Staff Report & Recommendation

Historic Preservation Board

SUBJECT: HPB18-0252, 355 19th Street.

The applicant has submitted plans entitled "Park Avenue Hotel" as prepared by Revuelta

Postcard of the Park Terrace Apartments, postmarked November 2, 1957, catobear.com

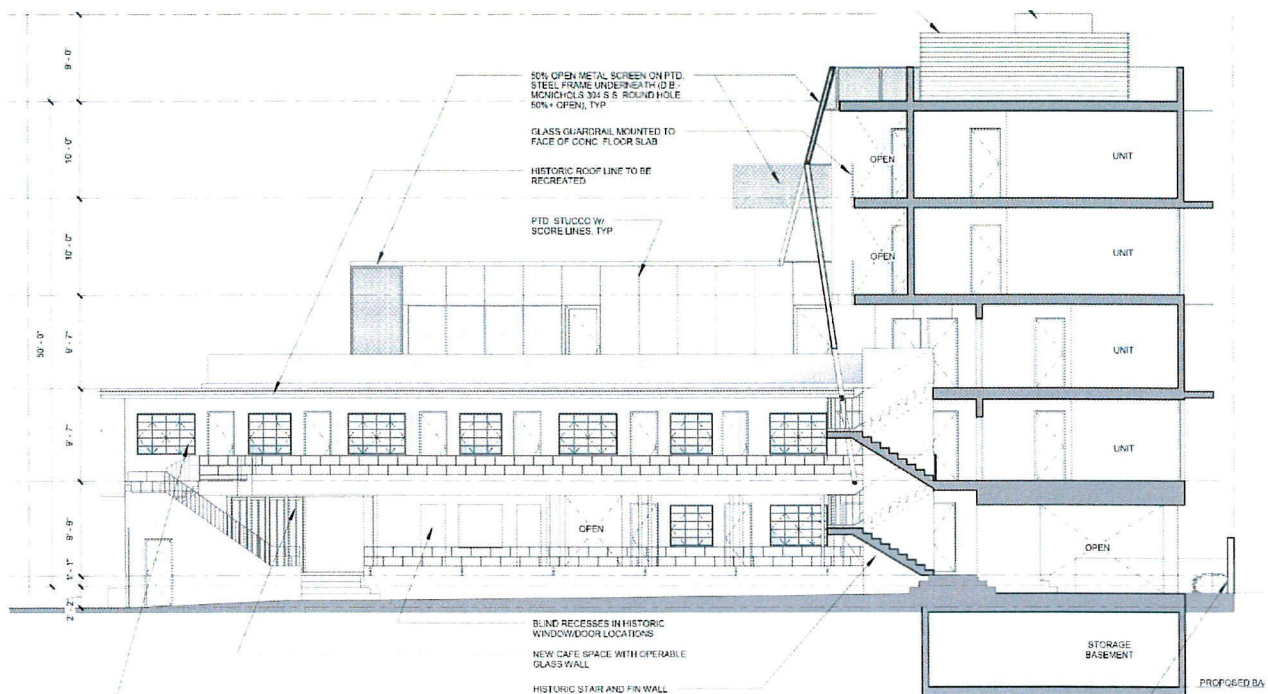
Contrary to this statement, staff believes that restoration of the above mentioned features of the existing building, in combination with the reintroduction of the original screening elements and courtyard railings, as seen in the image below, could be successfully accomplished in a manner which highlights this excellent example of low-scale Post War Modern multifamily residential architecture.

Consequently, staff would strongly recommend that a more thoughtful examination of the property's character defining features be undertaken and a modified demolition plan be developed in a manner which more appropriately captures the spirit of the original design. This could include the retention of larger portions of the wings including the elevated pedestrian bridge. Staff has provided examples on the following page of similar projects approved by the Board in the immediate neighborhood which have successfully incorporated a new 5-story addition with an existing 2-story garden style Post War Modern building.
